MEMORANDUM TO: Daniel S. Collins, Acting Chief, Section 2  
Project Directorate IV  
Division of Licensing Project Management  
Office of Nuclear Reactor Regulation  
/RA/  
FROM: Girija Shukla, Project Manager, Section 2  
Project Directorate IV  
Division of Licensing Project Management  
Office of Nuclear Reactor Regulation  
SUBJECT: SUMMARY OF MEETING HELD ON OCTOBER 11, 2005, WITH THE  
WESTINGHOUSE OWNERS GROUP TO DISCUSS RESUBMITTAL OF  
WCAP-16168-NP, "RISK-INFORMED EXTENSION OF REACTOR  
VESSEL INSERVICE INSPECTION INTERVAL"

### **MEETING WITH THE WESTINGHOUSE OWNERS GROUP TO DISCUSS RESUBMITTAL OF WCAP-16168-NP, "RISK-INFORMED EXTENSION OF REACTOR VESSEL INSERVICE INSPECTION INTERVAL"**

OFFICE OF NUCLEAR REACTOR REGULATION STAFF'S COMMENTS  
ON THE TECHNICAL BASIS FOR THE PTS RULEMAKING TO REVISE 10 CFR 50.61  
PREPARED BY THE OFFICE OF NUCLEAR REGULATORY RESEARCH  
AS DISCUSSED IN THE MEETING WITH WOG ON RESUBMITTAL OF WCAP-16168  
ON OCTOBER 11, 2005

Figure 6.20. Reactor Vessel Downcomer Fluid Temperatures - MIST Test 4100B2.

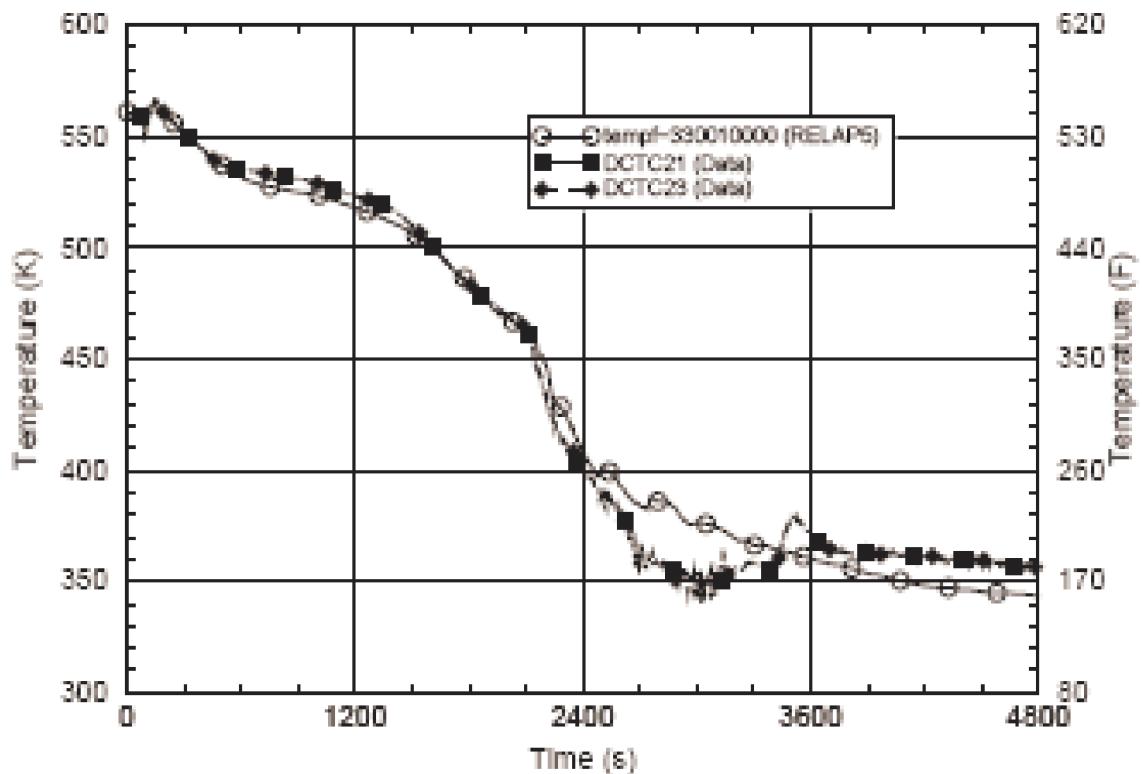
Based on review of only the few comparisons of RELAP results to test data that are contained in NUREG-1806, the Multi-Loop Integral System Test (MIST) Test 4100B2 shown in Figure 6.20 (shown on next page) on page 6-123 seems like a possible candidate for significant under-prediction of the thermally-induced

stress. It shows an over-prediction of temperature during a small time segment at a temperature of approximately 170° F. The maximum temperature difference is about 58° F, and it occurs at the point where the time derivative of the temperature is most under-predicted. Consequently, it seems like the stresses predicted from the RELAP results are likely to be less than the stresses predicted from the MIST data at time when the metal temperatures are low enough to create a non-zero probability of brittle fracture. The NUREG-1806 text does note this, but ends with a statement that RELAP over-predicted the downcomer fluid temperature by an average of 0.67° F over the entire test period. Nothing is said about the significance of the period when the temperature is over-predicted and its time derivative is significantly under-predicted. Please discuss, and quantify to the degree possible, the effects on TWCF of the absolute difference in temperature and the difference in the rate of change of temperature between experimental observations and RELAP calculations. Please perform this evaluation for the range of available test data rather than just for this example of MIST test data.
